**Re: 4101 Paseo Del Norte NE - Sports Complex  
Request Permanent C.O. - Accepted  
Engineer's Stamp dated: 6/11/2015 (C17D008)  
Certification dated: 12-13-2017**

**SPORTSPLEX**  
fract A,  
loop industrial park  
Albuquerque, New Mexico

grading and  
drainage plan

date  
8-31-15  
sheet  
c100

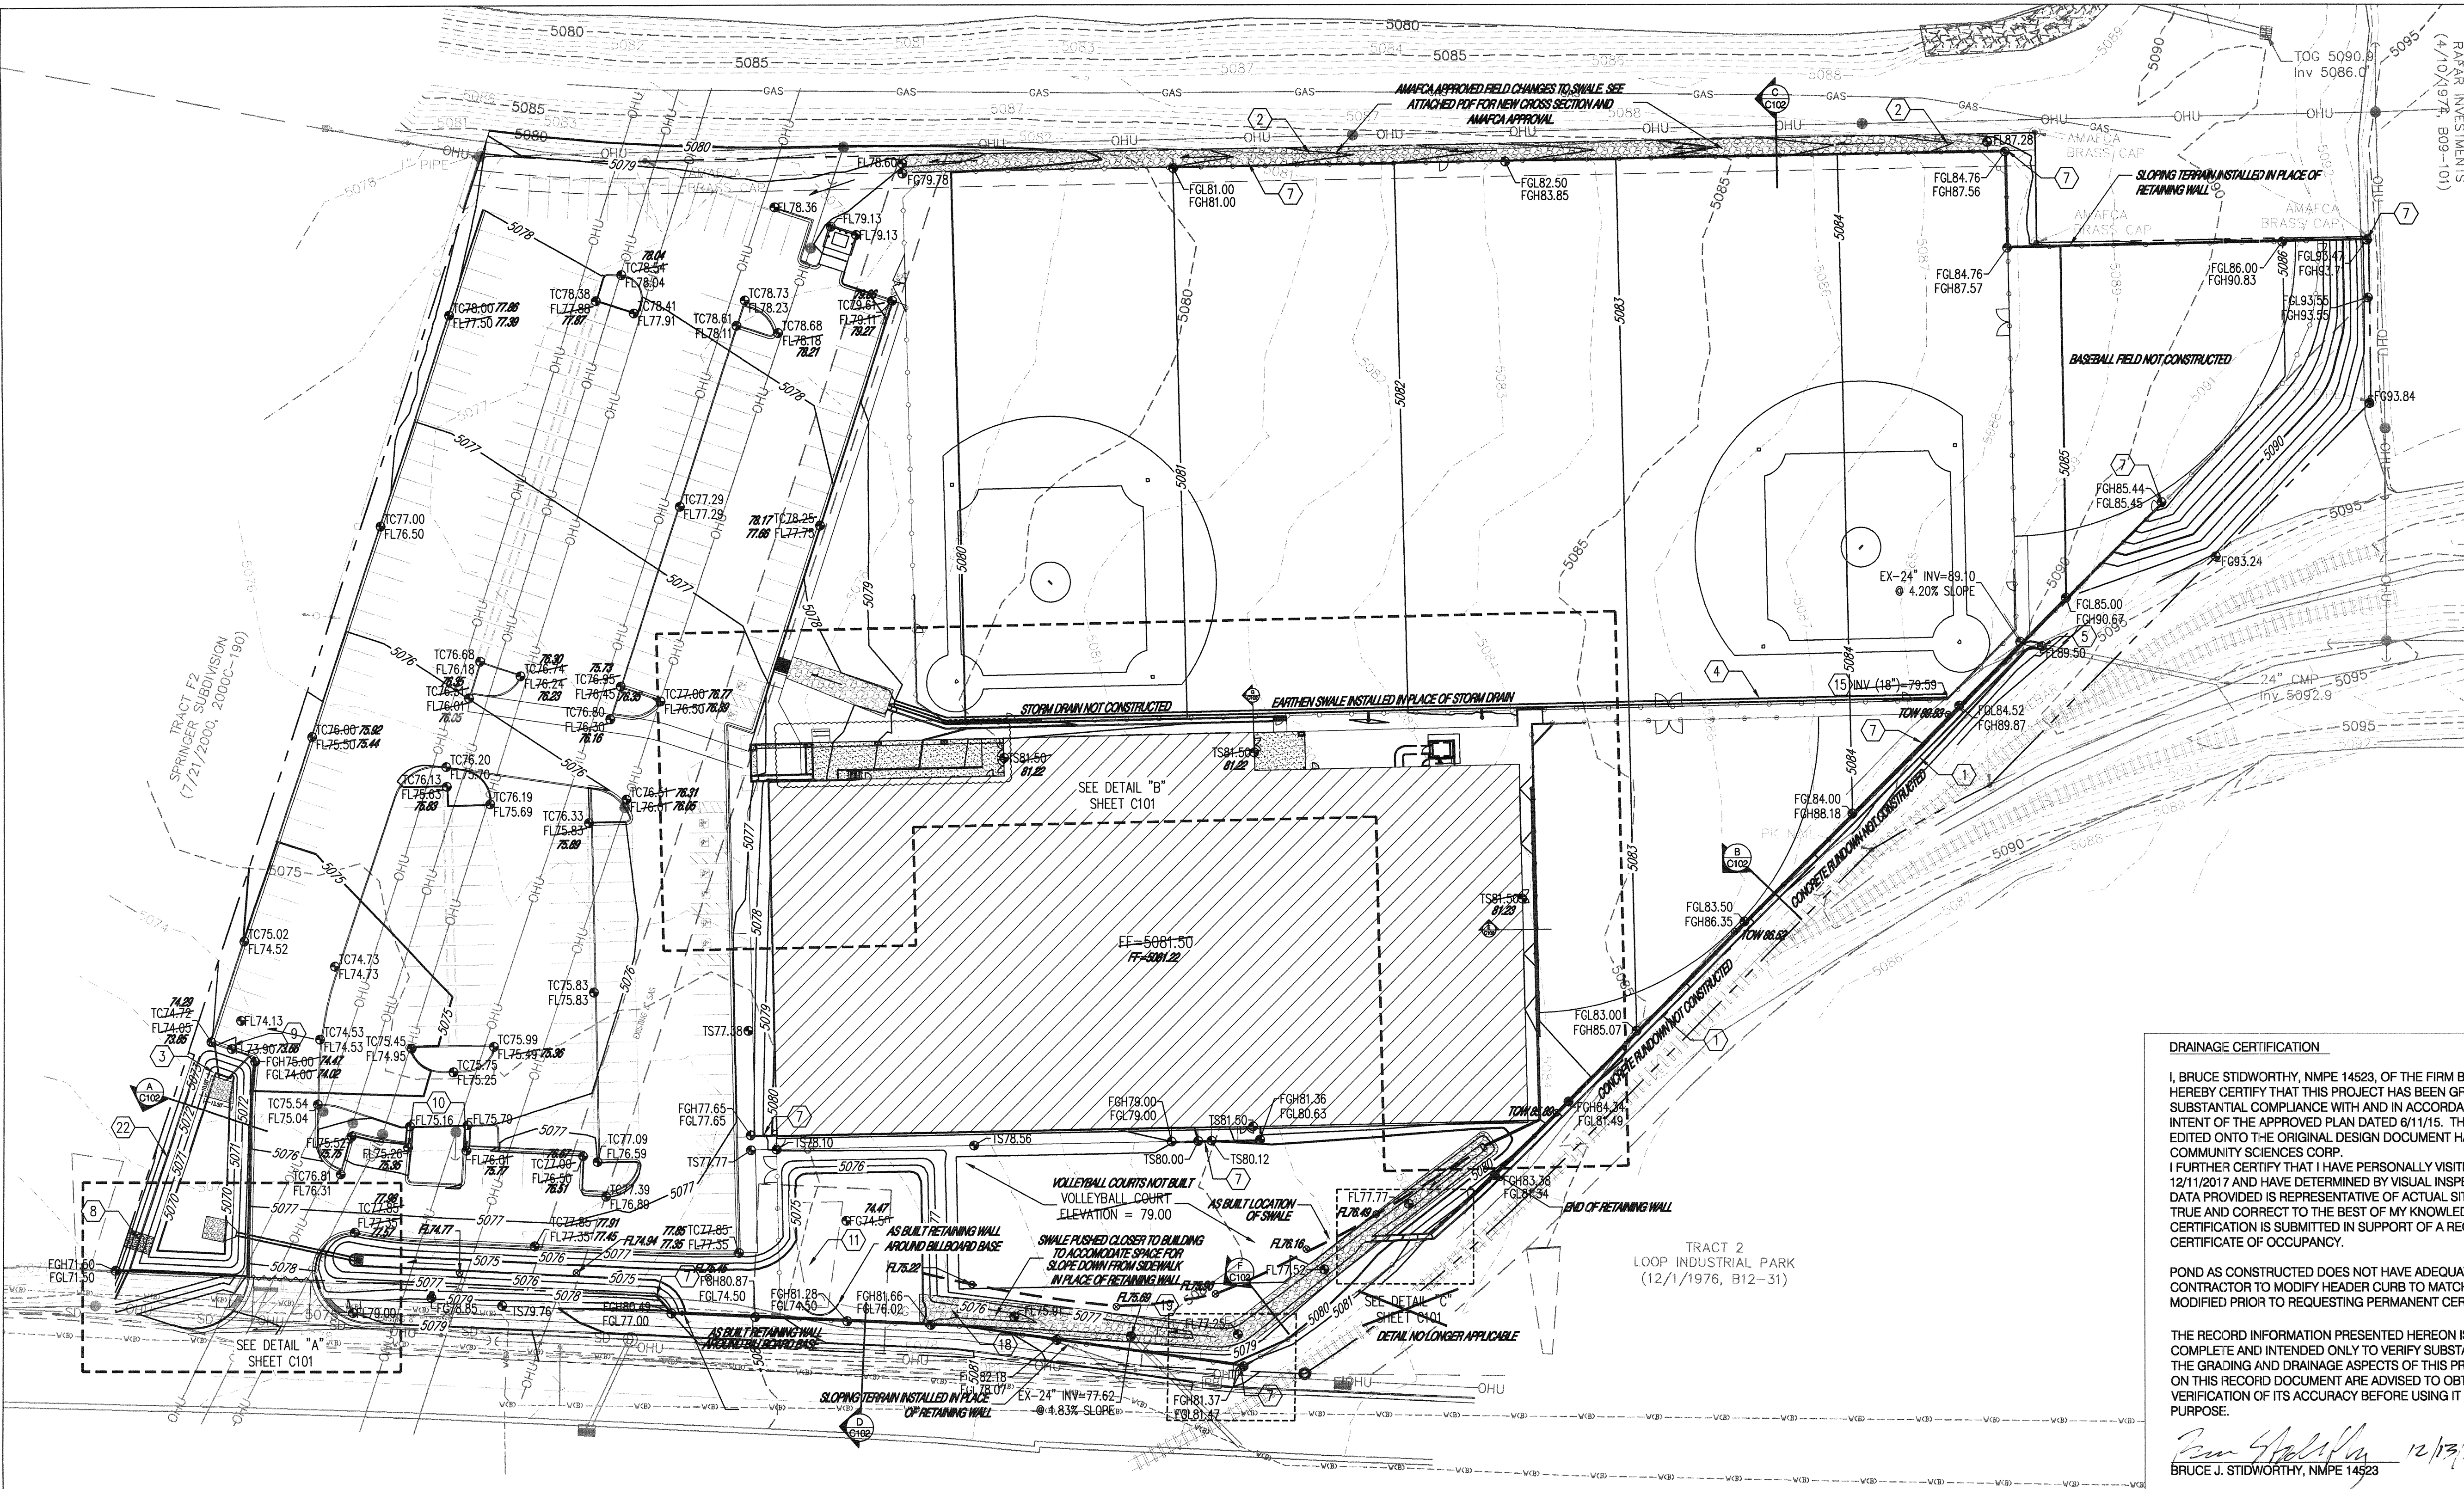
POND AS CONSTRUCTED DOES NOT HAVE ADEQUATE FREEBOARD. CONTRACTOR TO MODIFY HEADER CURB TO MATCH DESIGN AND WILL BE MODIFIED PRIOR TO REQUESTING PERMANENT CERTIFICATE OF OCCUPANCY.

date  
8-31-15  
sheet  
c101

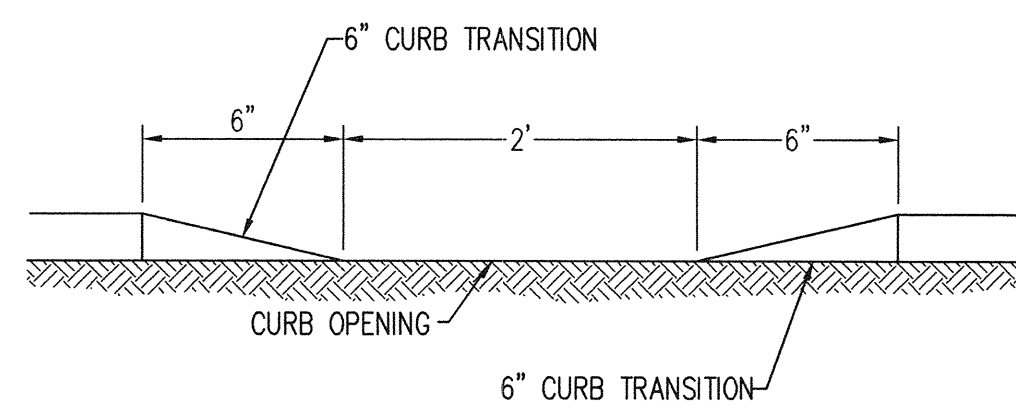
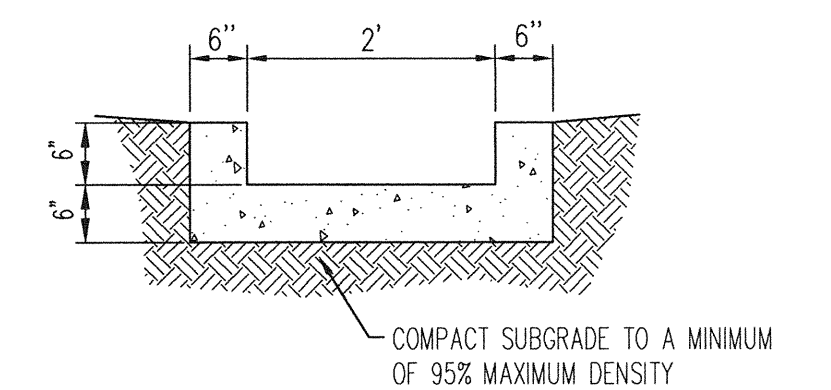
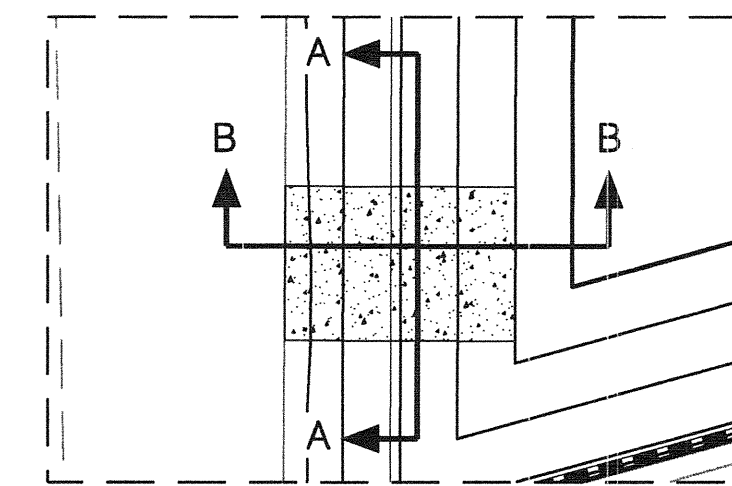
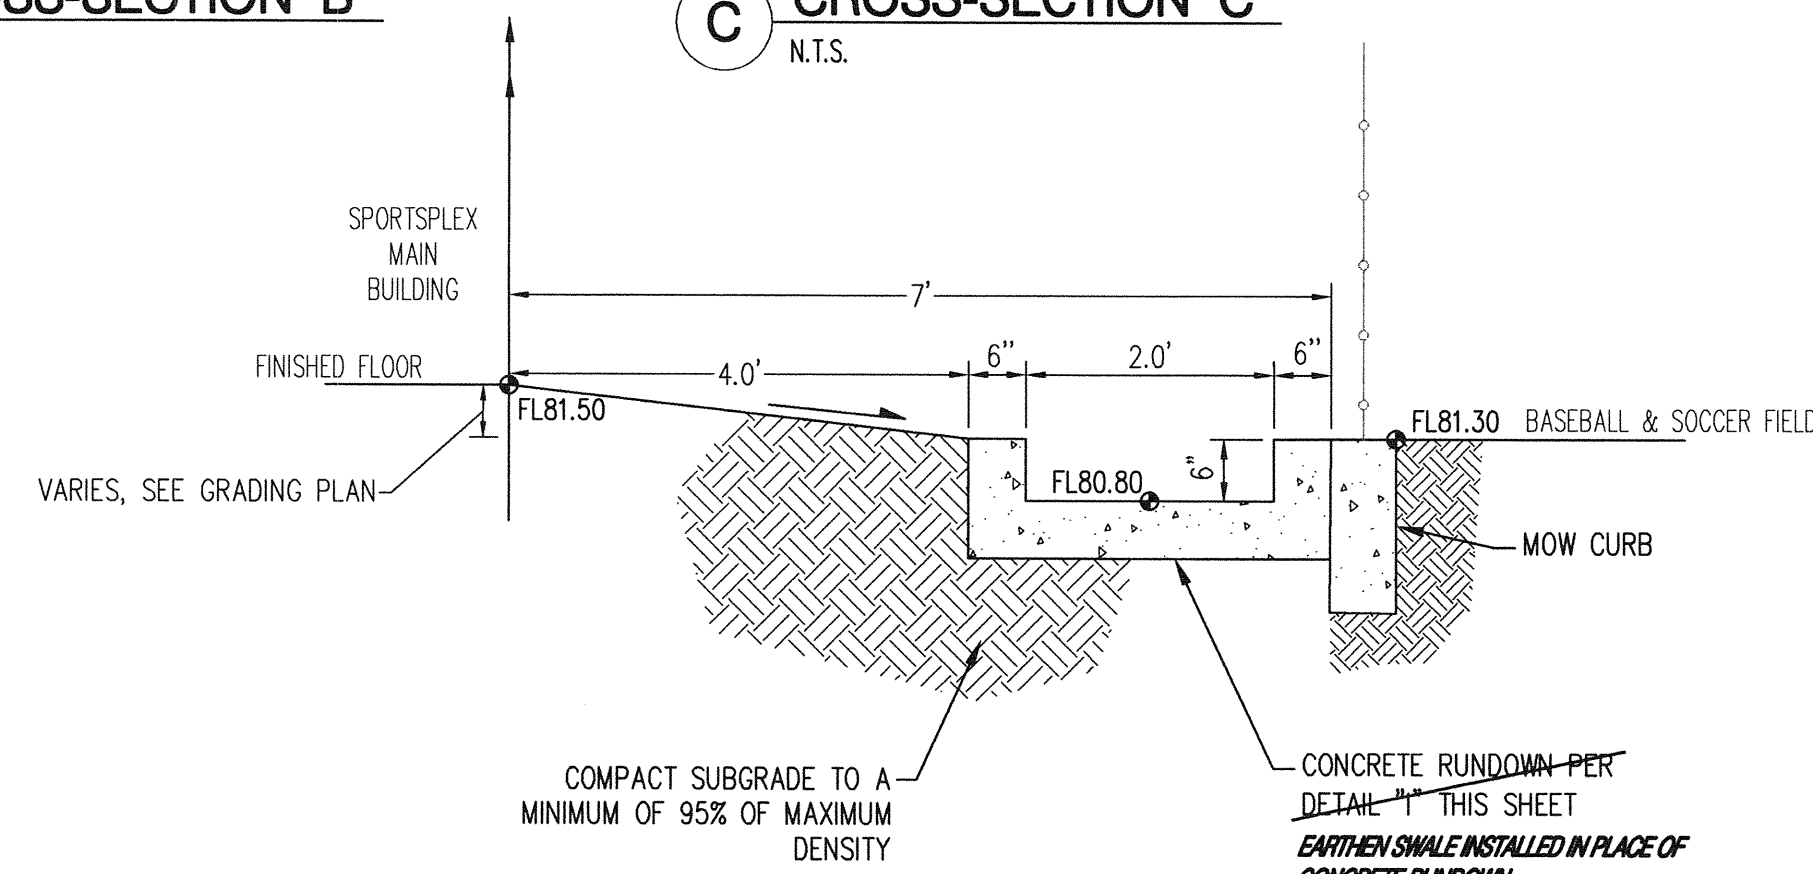
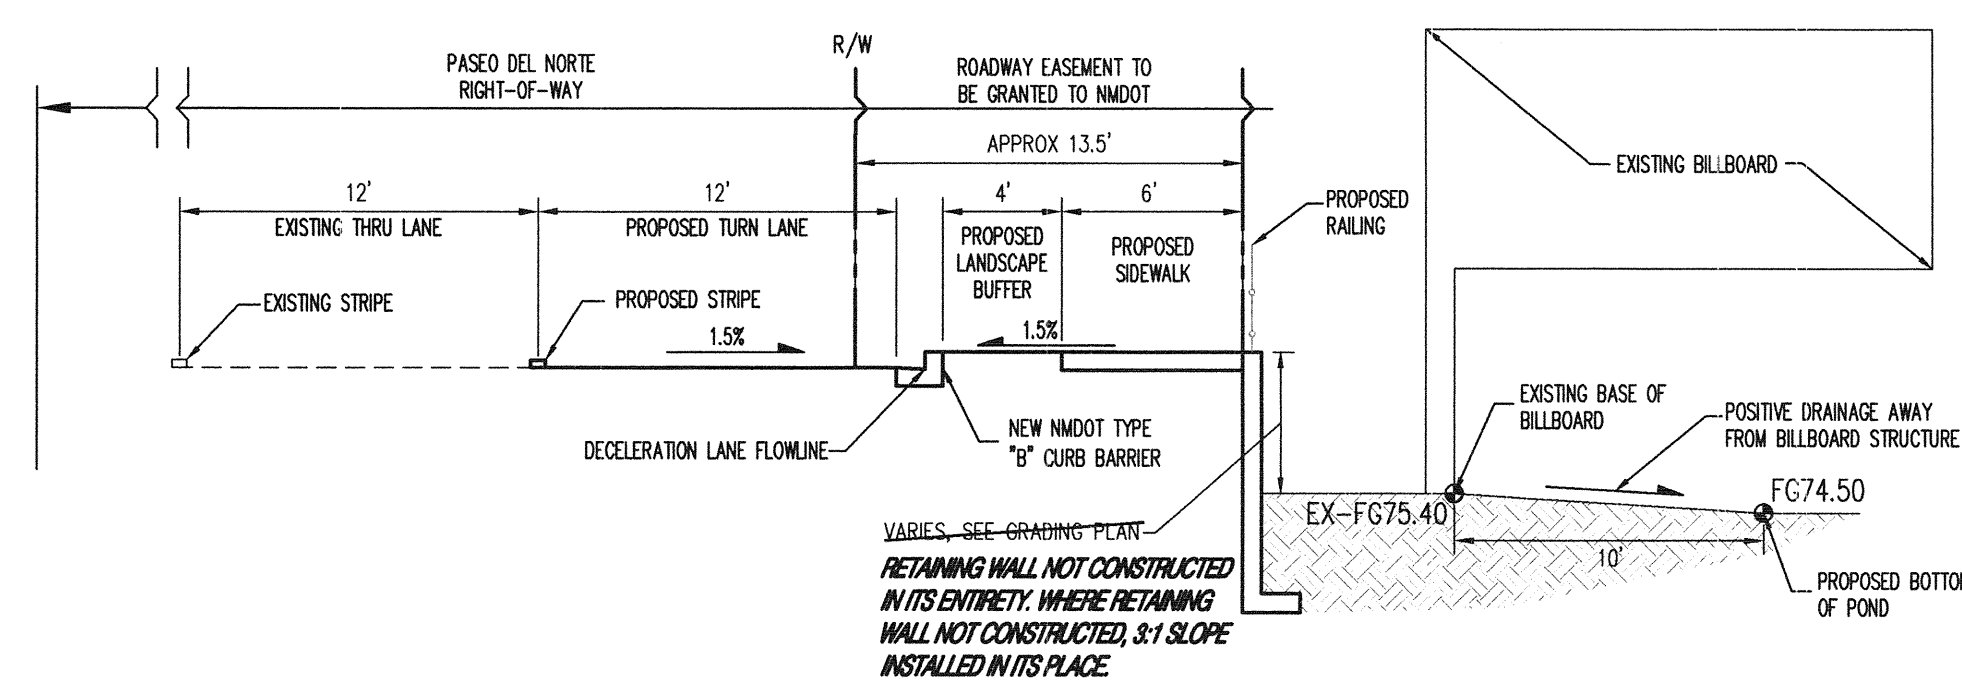
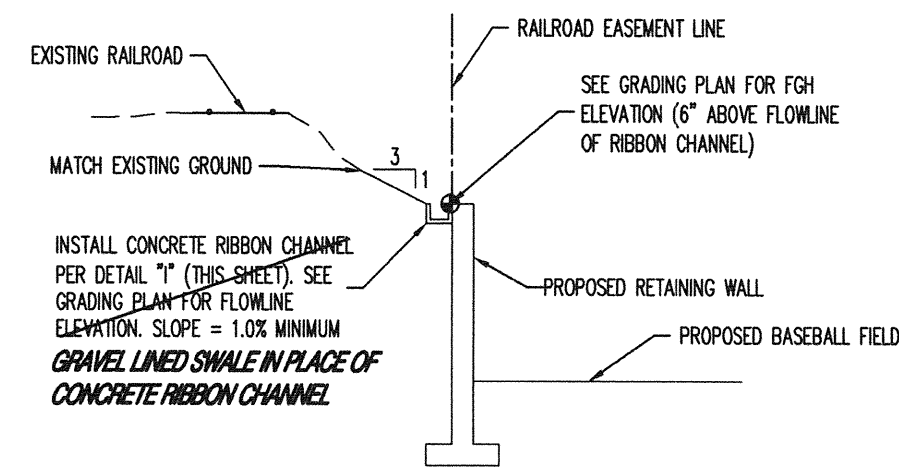
1. ~~INSTALL NEW CONCRETE RIBBON CHANNEL PER DETAIL "I" SHEET C102.~~ GRAVEL LINED SWALE INSTALLED IN LIEU OF CONCRETE RIBBON CHANNEL.
2. INSTALL NEW RIP RAP SWALE PER DETAIL "J" SHEET C102.
